Subject: Type HFA relay with latching mechanisms.

RELAY AND ACCESSORY SERVICE ADVICE LETTER

Subject: HFA RELAYS WITH LATCHING MECHANISMS Number 190.1
Issued by: R. R. Hammer November 16, 1987
Prepared by: S. S. Duerwachter

HFA LATCHING RELAY

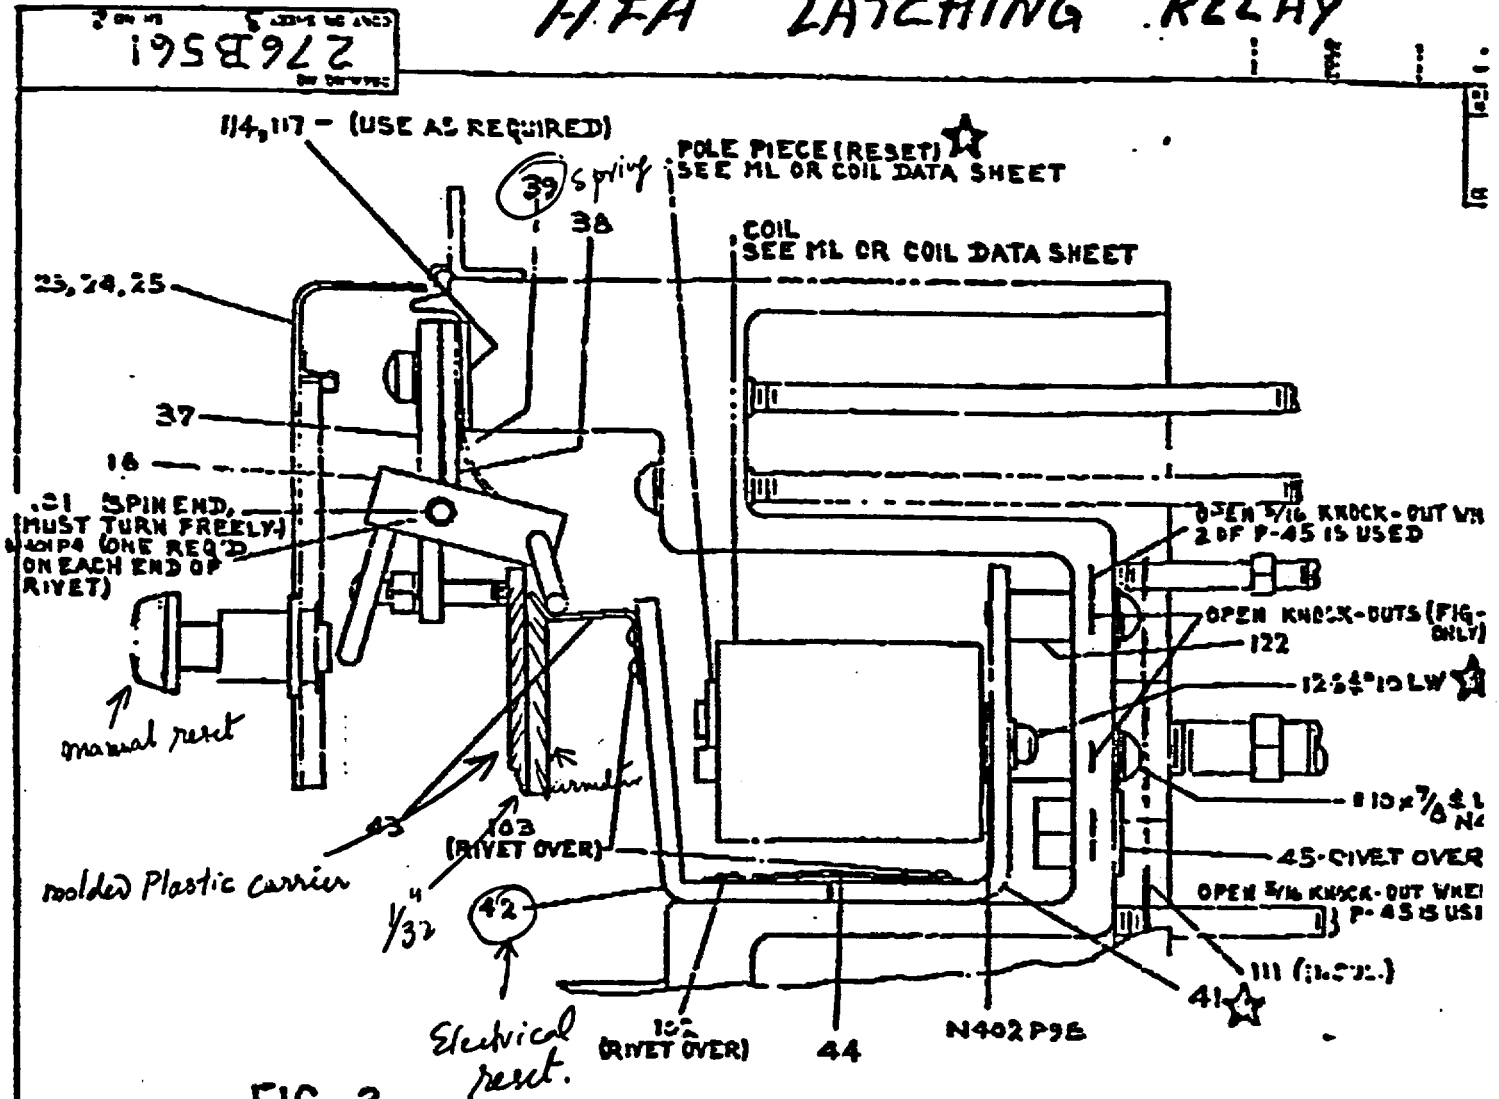
One user of latching-type HFA Relays has reported finding several Relays on which the latch engagement was less than the recommended minimum. With the armature in the latched position, each leg of the U-shaped latch should engage the top of the armature by at least 1/32 inch. There is a possibility that with less than the recommended minimum latch engagement, the relay could unlatch incorrectly.

Our investigation into this report has led us to conclude that latch engagement of less than 1/32 inch may be caused by two circumstances. If there is insufficient clearance between the top of the relay armature and the top of the molded moving contact carrier, it could prevent the mechanical latch from reaching the minimum 1/32 inch engagement. The second reason could be insufficient tension by the formed leaf spring that rotates the latch to its fully engaged position. If this leaf spring does not have proper tension, there is a possibility that the spring will relax before full engagement between the latch and armature is achieved.

1. Measure the distance between the top of the molded contact carrier and the top of the relay armature. This distance should be a minimum of 1/32 inch.

1. With the armature fully depressed against the Pole Piece, check to see if the Latch is fully rotated by pulling up on the latch assembly. If the latch is fully rotated, there should be no motion of the latch, since the latch should be held against the armature by spring tension.

- a. If there is insufficient clearance between the top of the molded moving contact support and the top of the armature, a small portion of the molded support can be removed by filing. This can be done as follows:

1. Remove the armature assembly from the relay.
 2. Disassemble armature assembly, maintaining the proper orientation of contact springs and moving contacts.

3. File approximately 1/16 inch from the top of the contact carrier.
 4. Reassemble armature assembly, maintaining original orientation of contact springs and moving contacts, and recheck for at least 1/32 inch clearance, as mention in (A1).

5. Replace armature assembly in Relay.
- b. If full latch rotation is not present:
 1. Remove latch assembly by removing the 10-32 screw at the top of the latch assembly.

2. Re-form leaf latch spring to have less curve (flatter spring).
 3. Reassemble latch assembly and check for full rotation.
 4. If relay is electric reset, check to ensure that relay resets with 60% of rated voltage applied to the reset coil circuit.
